COY PLANNING COMMISSION

- APPLICATION:**
- A. Negative Declaration
 - B. Variance to waive standard surfacing requirement for outdoor storage area for 3.7+ vacant areas.
 - C. Plan Review of a 42,000 square foot heavy equipment assembly building on 10+ vacant acres in the Light Industrial (M-1(S)-R) zone.

LOCATION: Northeast corner Raley Boulevard and Vinci Avenue

APPLC.NO. P86-160 **MEETING DATE** June 12, 1986 **ITEM NO.** 6

EXHIBIT E

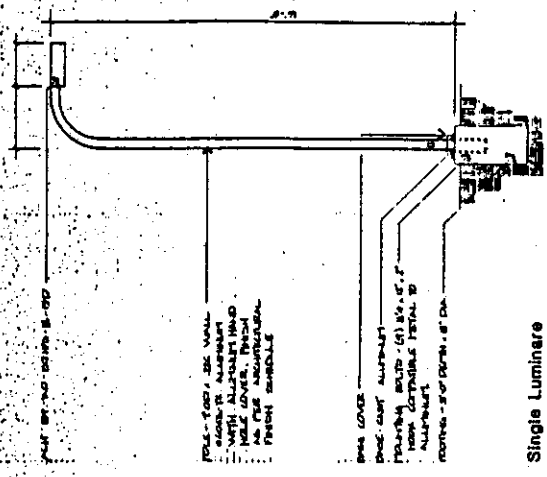
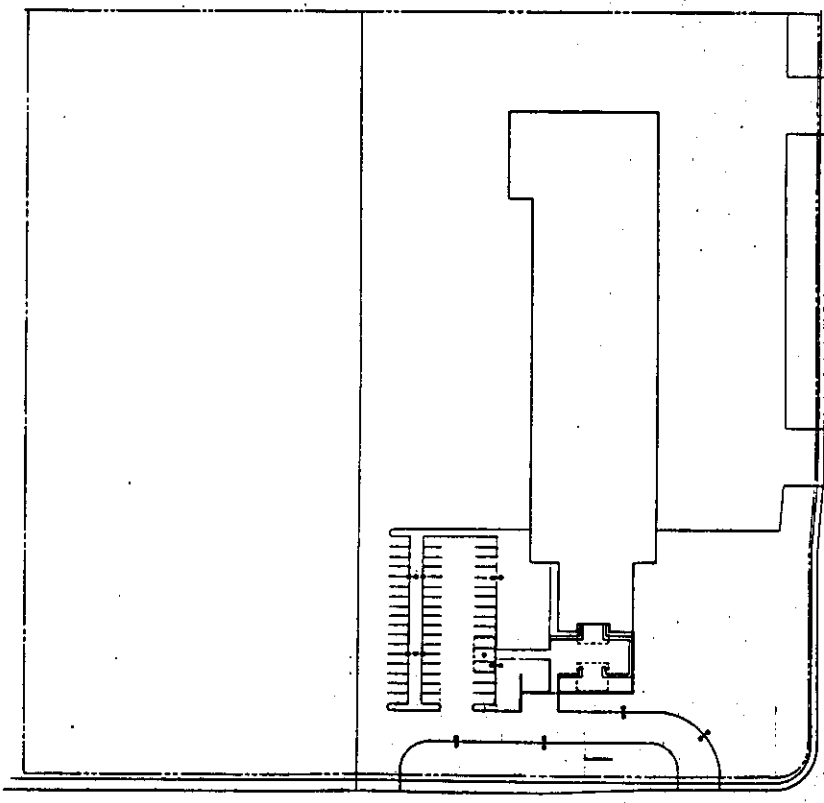
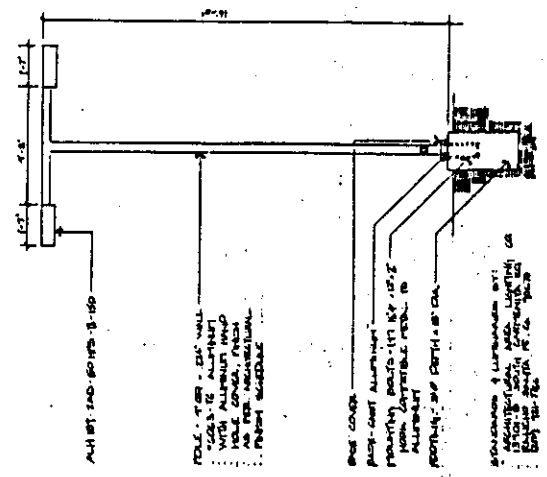
- A. The applicant's plans show parking lot lighting as shown on Exhibit E. Lamps will be 16 feet above the ground and designed to direct light on site. The outdoor storage area will have 30-foot high poles along the north and east property lines with lights focused onto the storage area. No glare should reflect off site.
- B. The corporate sign and flagpoles will be illuminated from a ground well (see Exhibit N).

- a. Parking Lot layout;
 - b. Landscaping and irrigation plan;
 - c. Fencing location;
 - d. Building Design.
2. All lighting shall be directed on site.
3. Sign and flag poles shall be relocated to be a minimum of 25 feet from road right-of-way.

EXHIBIT C

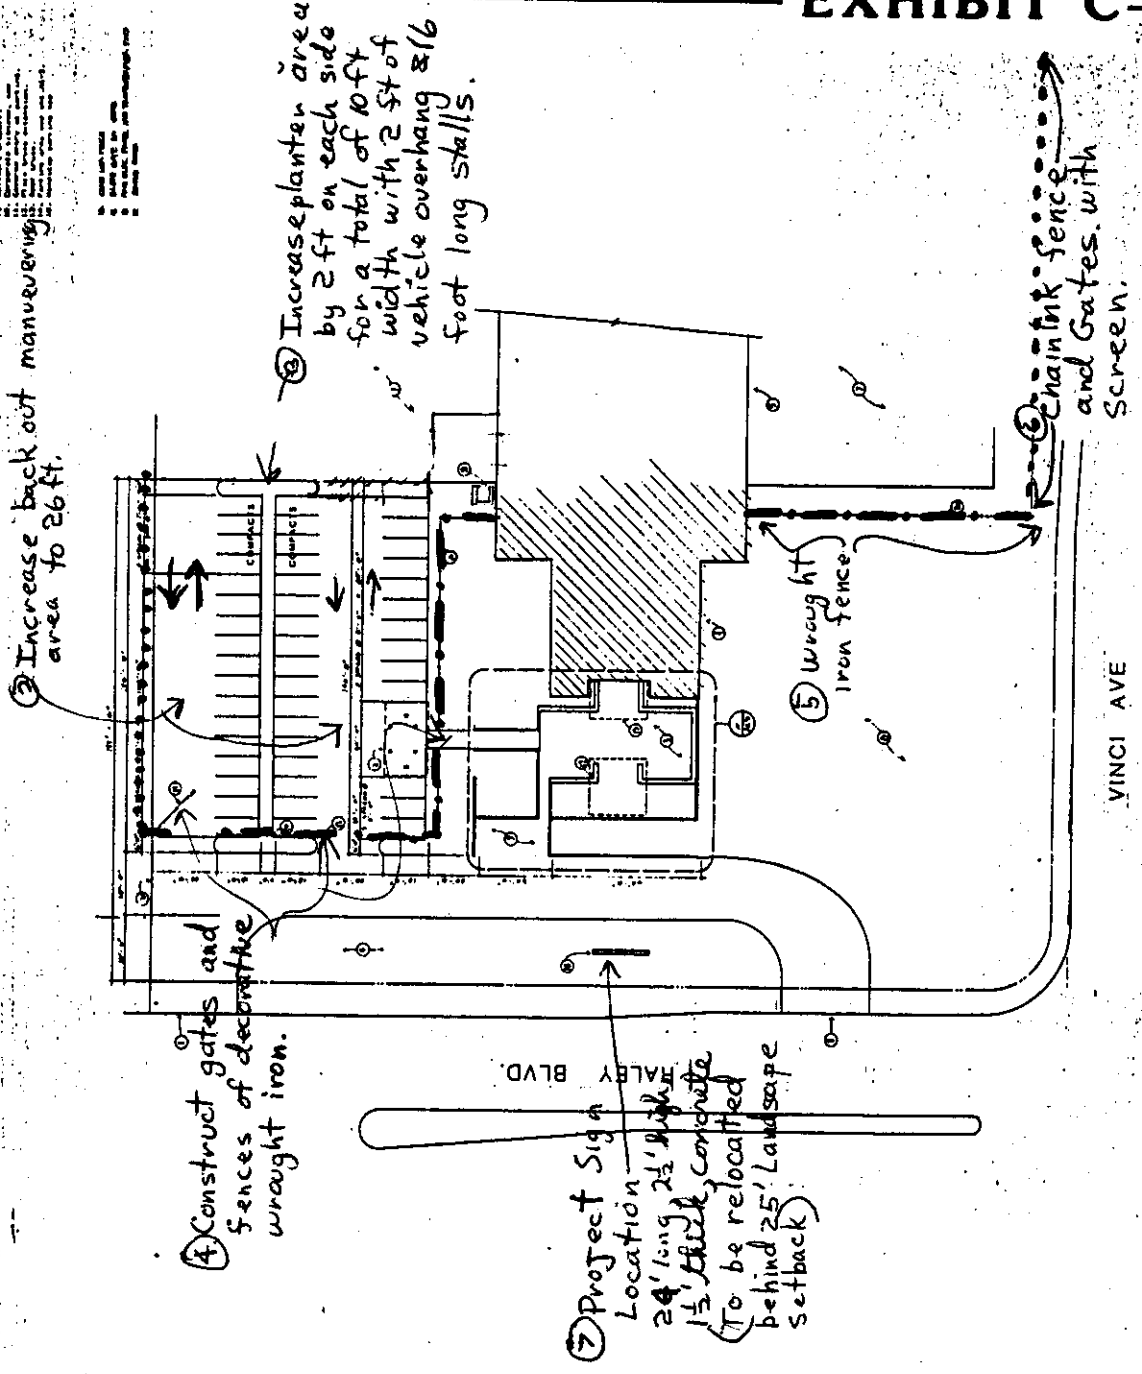
2. The Raley Boulevard frontage is recommended for vinyl-coated chainlink fencing from the northern parking lot entryway to the fence located south of the warehouse to Vinci Avenue as shown on Exhibit C. The purpose of a decorative fence is to enhance the entryway to the center and yet maintain security. Other decorative materials are available, however, staff observes vinyl-coated fencing to be more compatible with the use. All gates should be so designed to reflect the material and decorative design of the fence. The applicant has indicated he prefers vines along the fence to provide screening.

CORPORATE SIGN & FLAG POLES

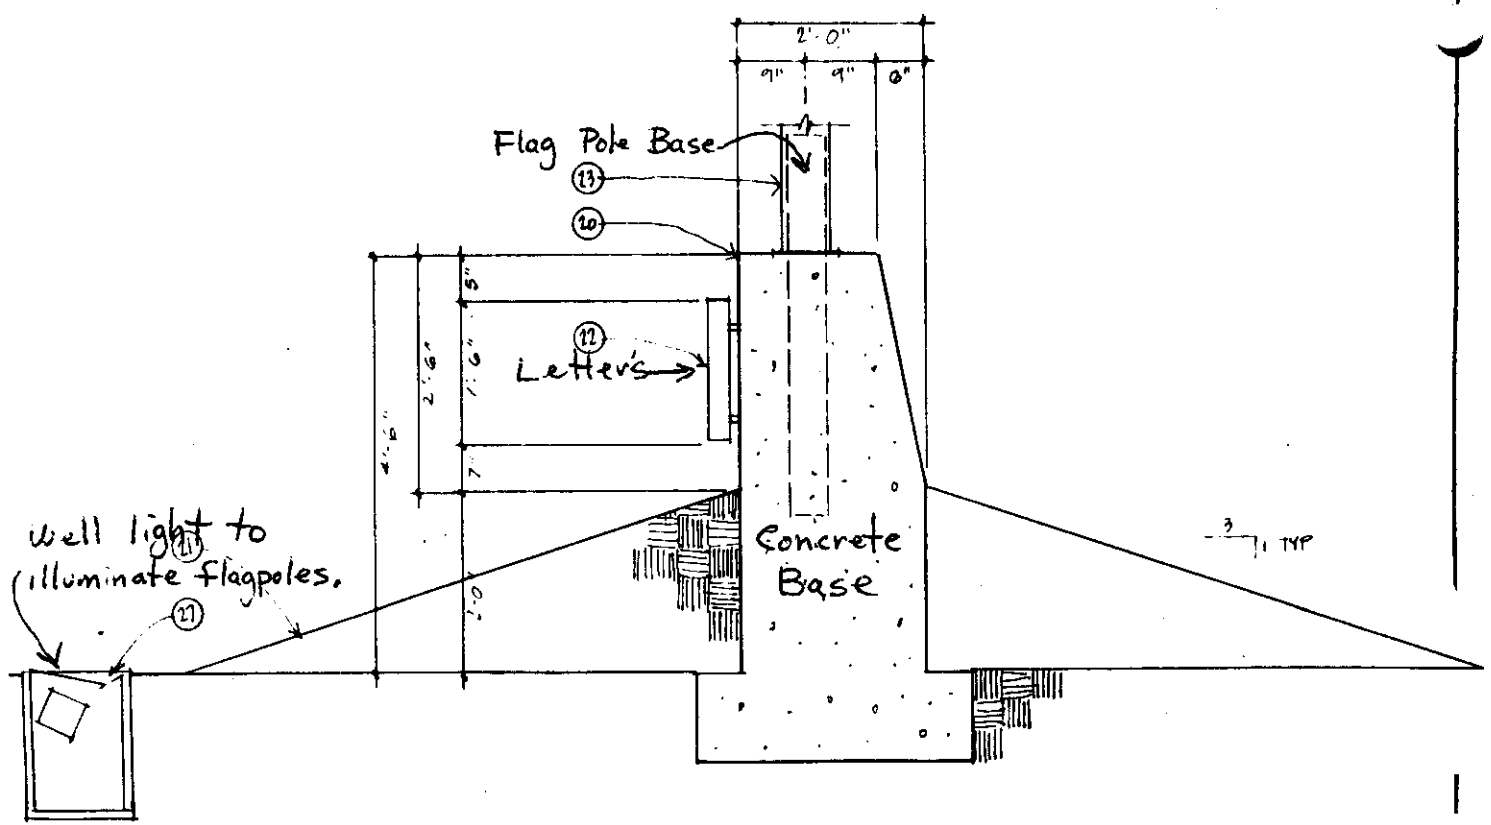
- A. The only sign included as part of the application is presented in Exhibit N. The sign complies with the requirements of the City Sign Ordinance relative to area and dimensions. The applicant proposes three flagpoles not to exceed 40 feet in height as measured from the ground. No corporate flag is allowed under the City Sign Ordinance.
- B. The location of the sign is approximately 15 feet back from the Raley Boulevard right-of-way. Signs and flagpoles cannot be located within the 25-foot front setback. The sign will be required to be relocated behind the 25 setback or to the corner of the parcel behind the landscape setback area.
